UN Regulation No. 131

Uniform provisions concerning the approval of motor vehicles with regard to the Advanced Emergency Braking System (AEBS) for M₂, M₃, N₂ and N₃ vehicles

Industry proposals in purple text

Figure 2:
Right turn or left turn of a forward vehicle

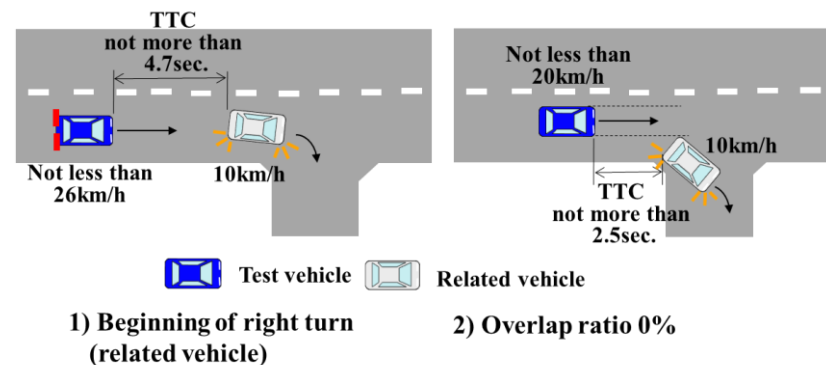
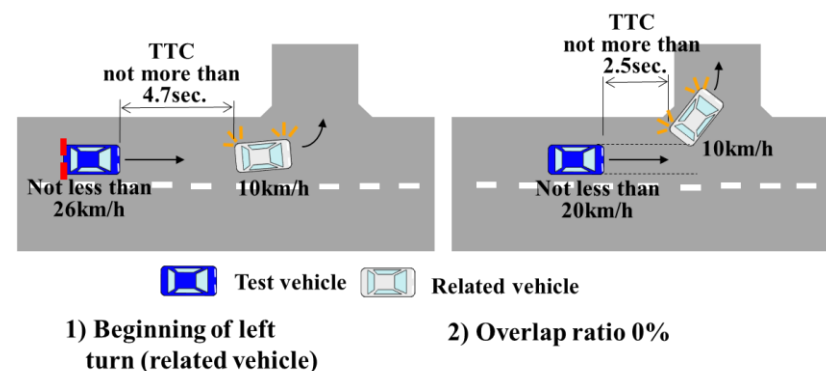
The blue car needs to be changed from passenger vehicle to large vehicle.

Figure 4:
Lane change due to road construction

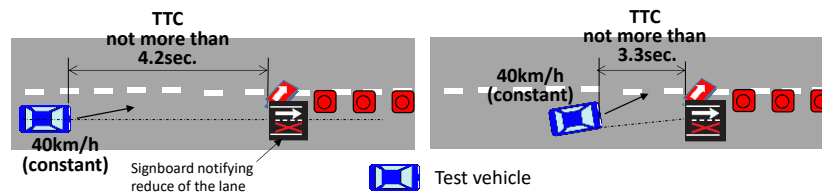
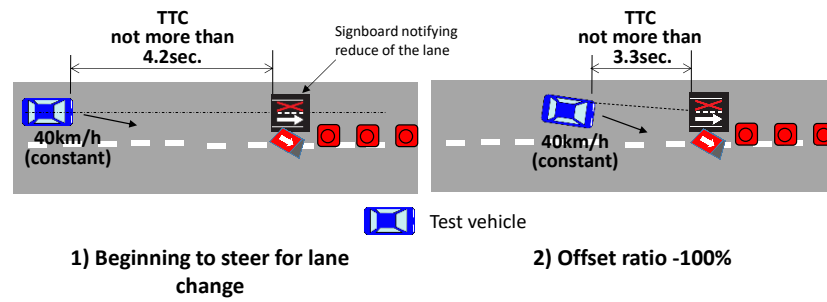
The blue car needs to be changed from passenger vehicle to large vehicle.
